**Staff Report**  
**City of Richmond, Virginia**

**Commission of Architectural Review**

10. COA-128334-2023	<b>Final Review</b>	Meeting Date: 4/25/2023
Applicant/Petitioner	Matson Roberts Jr., SMS Architects	
Project Description	Various exterior alterations including a side addition, and rear and side second-story trellis.	
Project Location		
Address: 2315 Monument		
Historic District: Monument Avenue		
High-Level Details: <ul style="list-style-type: none"> <li>• construct a side addition,</li> <li>• install new garage doors,</li> <li>• install new lattice detailing on top of the rear and side faux wall,</li> <li>• remove a rear wood privacy fence and replace with a stucco wall and wood gate,</li> <li>• install a new door on the side elevation,</li> <li>• install treillage,</li> <li>• and install an outdoor staircase to the roof of the garage.</li> </ul>		
Staff Recommendation	Approval, with Conditions	
Staff Contact	Samantha Lewis, <a href="mailto:Samantha.lewis@rva.gov">Samantha.lewis@rva.gov</a> , 804-646-5207

Figure 5. Decorative Gate located at 2309 Monument

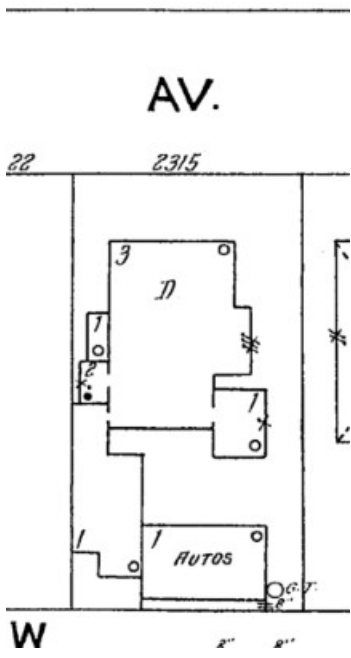
<b>F. Treillage</b>		
Standards for Site Improvements, p. 77, #12	<p><i>When considering the design of new fences, remember that some districts, such as Church Hill, historically featured some modest brick terraced areas in front yards, while some other districts, such as Monument Avenue and West Grace Street, historically did not. <u>In the event of a front yard landscaped area, the design should seek simplicity, rather than elaboration.</u></i></p> <p><i>Where physical or documentary evidence does not exist, the proposed front yard landscaped area should <u>be compatible in design, materials, and location</u>, and should look to precedent on the block face or the block face opposite, or within the district. ... Suitable design, materials, and location will vary by district. In any event, the non-historical over-development of front yards should be avoided.</i></p>	The treillage will be set back 28 feet from the street and front property line; about 9 feet back from the façade of the primary structure. The treillage also intends to be behind the existing trees on the site. Staff notes that this location is appropriate and will not disrupt the visual rhythm of the street. The gate associated with the treillage in the front/side yard will be quite ornate. On a site visit, Staff observed a few examples of decorative fences and gates.
